TOWN OF YORKTOWN
WESTCHESTER COUNTY, NEW YORK
ROUTE 118 AND UNDERHILL AVENUE INTERSECTION

Capital Improvement Project #24-8

ADDENDUM NO. 3

ALTERING UTILITY MANHOLE
TO HIGHER ELEVATION
N.T.S

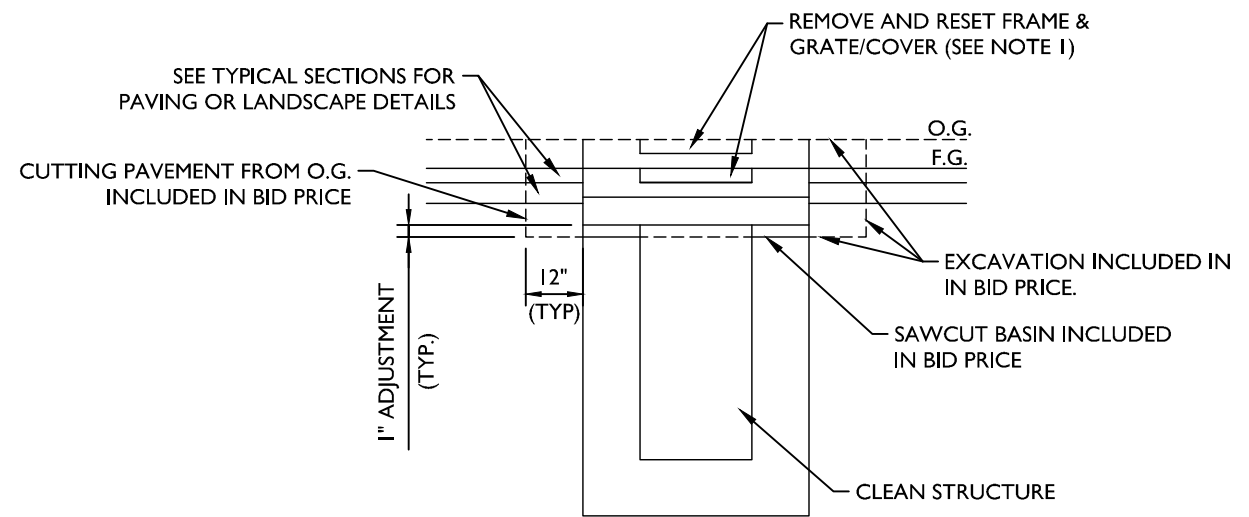
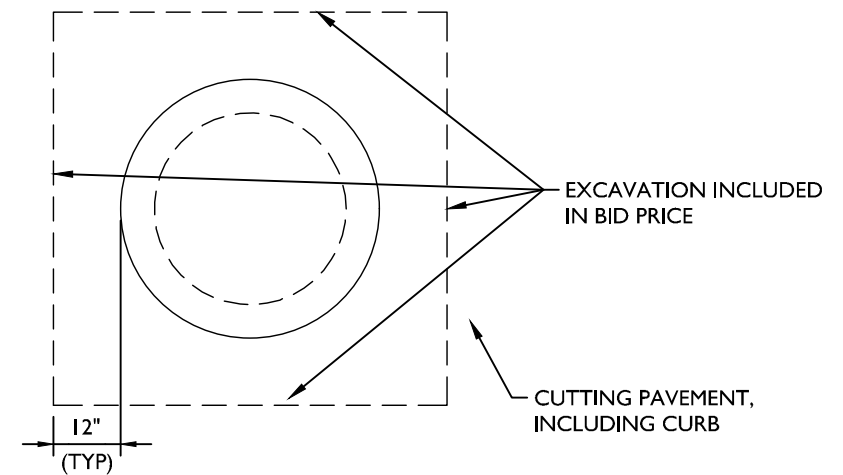
21. Item 660.65000101 shall apply for the Sewer Manhole located at approximate Sta: P125+43, 4.5' RT. (Southeast Corner of Route 118/Underhill intersection). The plan will be revised to indicate this and reissued prior to construction. In addition, the attached detail for Item 660.65000101 will be added to the plan set as well.
